LIMERICK GENERATING STATION UNITS 1 & 2

DESIGN ASSESSMENT REPORT

REVISION 2 PAGE CHANGES

THIS DAR SET HAS BEEN UPDATED TO
INCLUDE REVISIONS THROUGH 2
DATED 03/83.

FIGURE 7.1-12

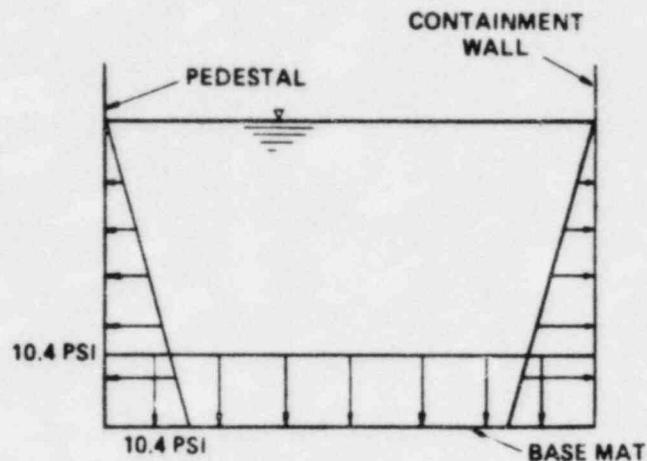
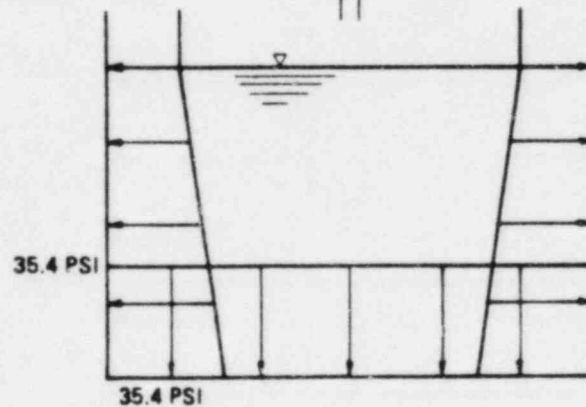
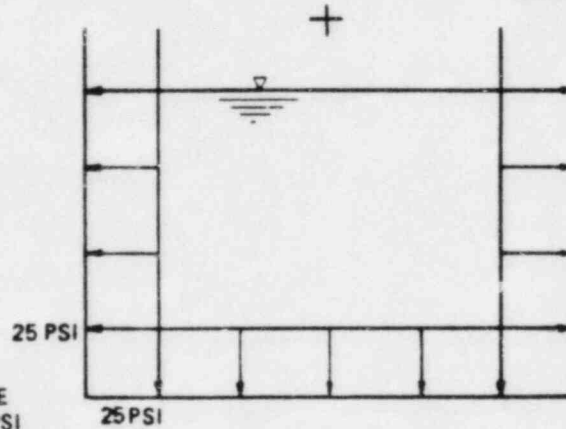
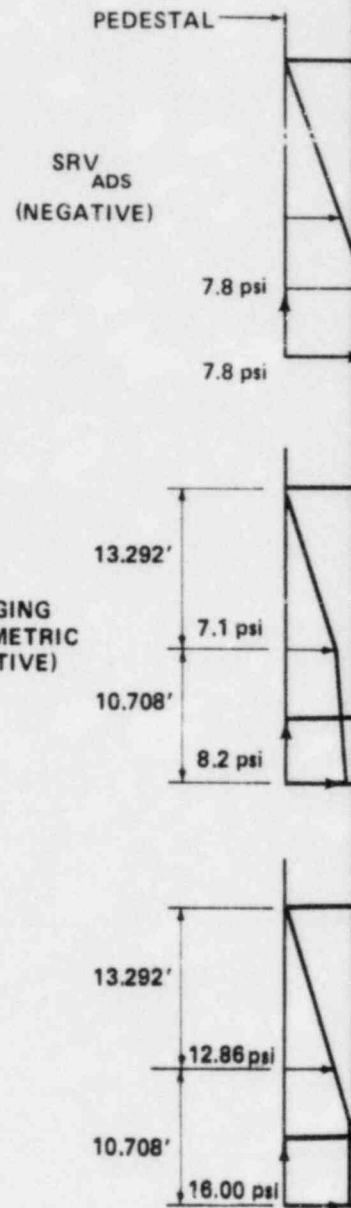
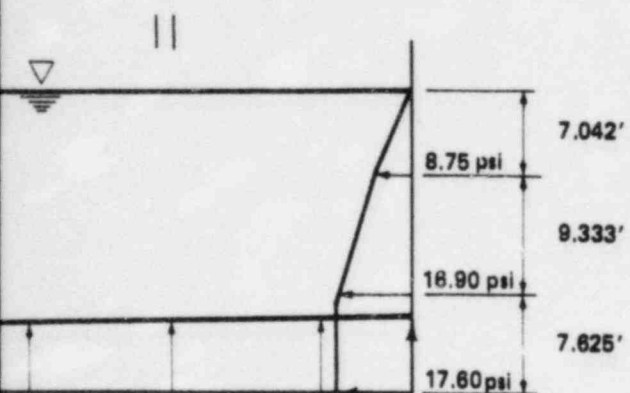
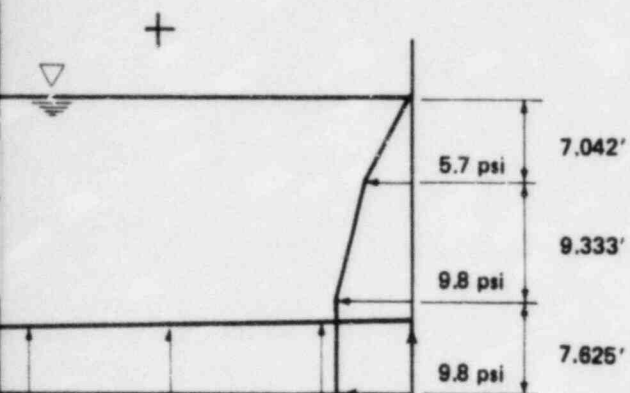
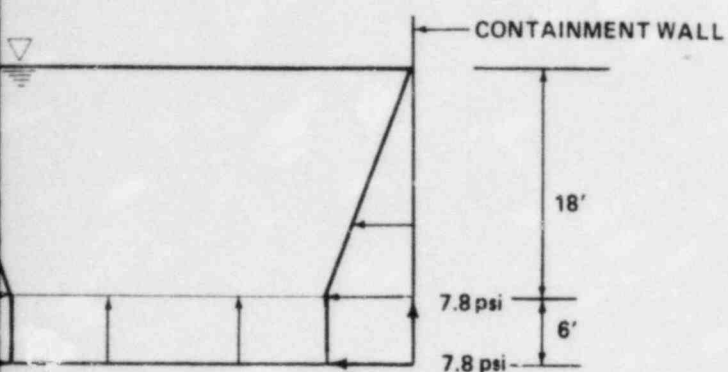
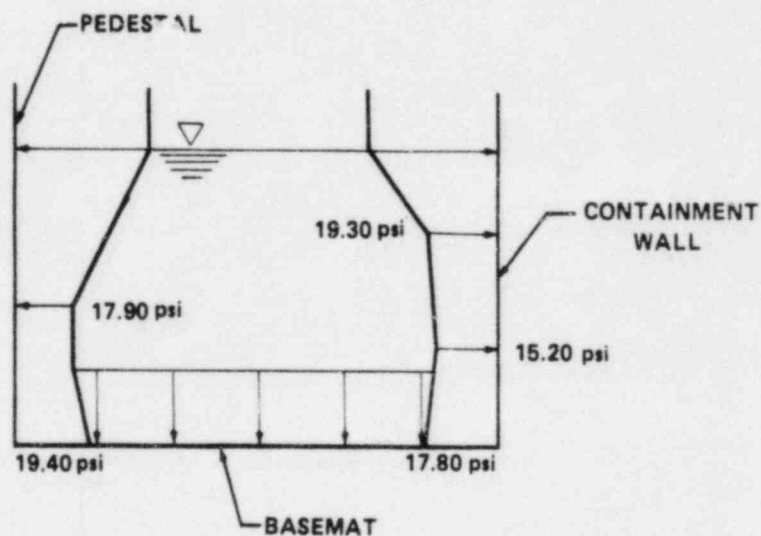
QUESTION 220.20 (DAR Section 7.1.3)

For the normal condition, the hydrostatic pressure on the basemat liner is 10.4 psi (positive) and the maximum negative pressure due to the actuation of all SRVs is 7.8 psi (negative). The distribution of these pressures on the suppression chamber wall is shown in Figure 7.1-12. The maximum net pressure is 2.6 psi (positive).

A maximum SRV dynamic negative pressure of 7.8 psi exists on the liner plate based on a consideration of all KWU pressure traces. The pressure is derived from KWU pressure trace No. 76 (Figure 4.1-26) multiplied by a 1.5 pressure multiplier to account for the difference in pool geometries and quencher constructions between Limerick and Brunsbuttel as described in Section 4.1.4.1. This SRV dynamic negative pressure was incorrectly provided in Section 7.1.3 as 11.67 psi and should be corrected to reflect 7.8 psi. When combined with the positive hydrostatic pressure of 10.4 psi, a net positive pressure of 2.6 psi exists on the liner plate.
